ALDER MARSH DAM

NDI ID No. PA-00153  
 DER ID No. 64-150

PENNSYLVANIA GAME COMMISSION

PHASE I INSPECTION REPORT  
 NATIONAL DAM INSPECTION PROGRAM

**RESULTS OF  
VISUAL INSPECTION**

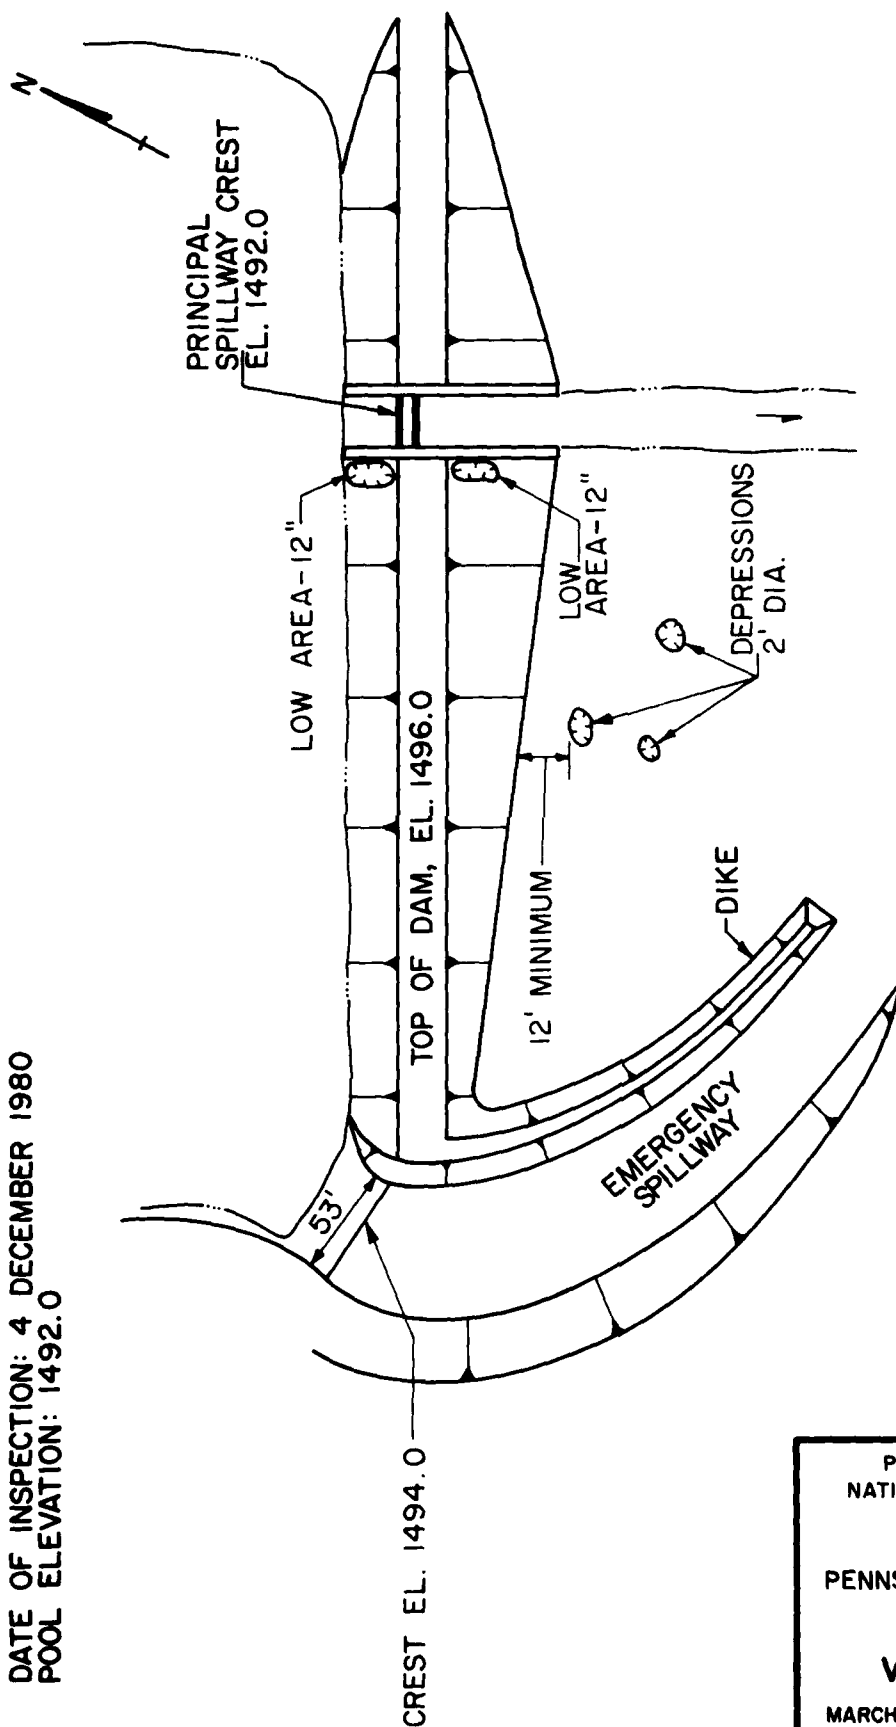
VISUAL EXAMINATION OF	OBSERVATIONS	REMARKS OR RECOMMENDATIONS
SURFACE CRACKS	None observed	
UNUSUAL MOVEMENT OR CRACKING AT OR BEYOND THE TOE	Several depressions beyond toe ~ 2 feet deep; minimum distance from toe about 12 ft.; 3 ft (1') below pool level.	Cause of depressions unknown; may be caused by settlement of uncompacted fill placed during construction.
SLOUGHING OR EROSION: Embankment Slopes Abutment Slopes	None	
CREST ALIGNMENT: Vertical Horizontal	Good	
RIPRAP FAILURES	None

VISUAL EXAMINATION OF	OBSERVATIONS	REMARKS OR RECOMMENDATIONS
CONCRETE WEIR	Vegetated channel at right end of dam.	Crest is approximately one foot higher than shown on design plans.
APPROACH CHANNEL	Well vegetated - no deficiencies observed.	Channel is narrower than shown on design plans; bottom width $\approx$ 53 feet.
DISCHARGE CHANNEL	Good - no obstructions.	Dyke along left side of channel prevents erosion of embankment toe.
BRIDGE AND PIERS	None

F. Emergency Spillway Channel  
(Looking Downstream)

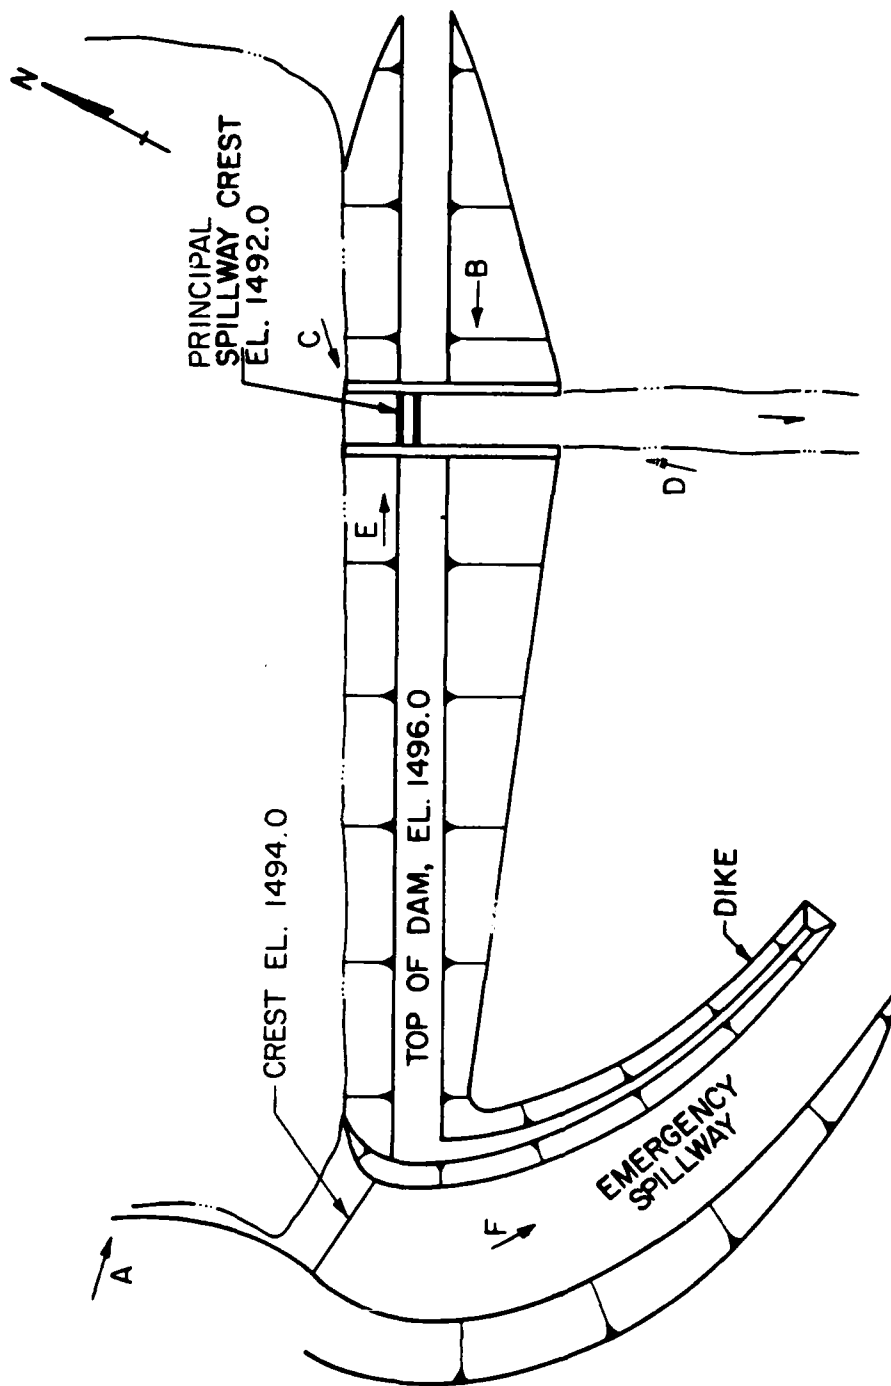
c. Appurtenant Structures. Both spillways are in generally good condition. The area between the principal spillway stoplogs has been filled with soil and rock to reduce seepage through the stoplogs. The emergency spillway channel is well vegetated. A small dike, not shown on the design plans, was constructed along the left side of the spillway channel to prevent erosion along the toe of the embankment. The emergency spillway approach channel is smaller and has a crest elevation approximately one foot above that shown on the design plans. The existing channel has a bottom width of 53 feet and a crest elevation of 1494.0 feet, as compared with the design bottom width of 65 feet and design crest elevation of 1493.0 feet.

(3) Appurtenant Structures. No conditions were observed that would indicate that either of the spillways could not operate satisfactorily in the event of a flood. The emergency spillway approach channel is smaller than that shown on the design plans and, therefore, has a correspondingly lower discharge capacity.

(1) Widen the emergency spillway channel and/or lower the spillway crest to make the spillway adequate.
